Transmission Expansion Advisory Committee

FirstEnergy Supplemental Projects

JCPL Transmission Zone

Changes to the Existing Supplemental Projects

JCPL Transmission Zone Scope Change s3274.1 - East Flemington 230-34.5 kV No. 3 Transformer, NJ

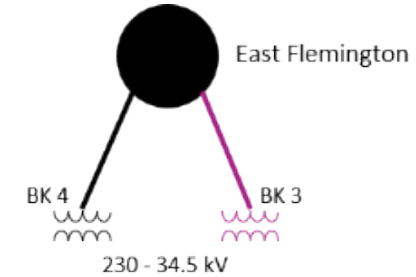
Reason: A 230-34.5 kV 90 MVA unit transformer will be installed instead of a 125 MVA unit.

Revised Solution:

Replace the 230-34.5 kV No. 3 Transformer at East Flemington Substation with a 90 MVA unit.

Install a 34.5 kV breaker with SCADA control

Upgrade transformer relaying.

- East Flemington 230-34.5 kV No. 3 Transformer:
 - Before Proposed Solution: 77 / 81 / 97 / 99 MVA (SN/SLTE/WN/WLTE)
 - After Proposed Solution: 90 / 95 / 108 / 117 MVA (SN/SE/WN/WLTE)

JCPL Transmission Zone Scope Change s3275.1 - East Flemington 230-34.5 kV No. 4 Transformer, NJ

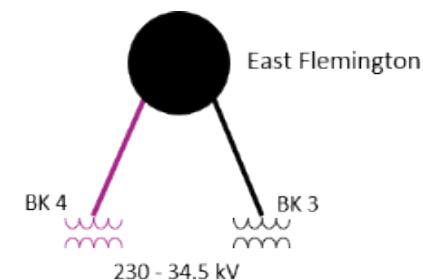
Reason: A 230-34.5 kV 90 MVA unit transformer will be installed instead of a 125 MVA unit.

Revised Solution:

Replace the 230-34.5 kV No. 4 Transformer at East Flemington Substation with a 90 MVA unit.

Install a 34.5 kV breaker with SCADA control

Upgrade transformer relaying.

- East Flemington 230-34.5 kV No. 4 Transformer:
 - Before Proposed Solution: 76 / 81 / 97 / 99 MVA (SN/SLTE/WN/WLTE)
 - After Proposed Solution: 90 / 95 / 108 / 117 MVA (SN/SE/WN/WLTE)
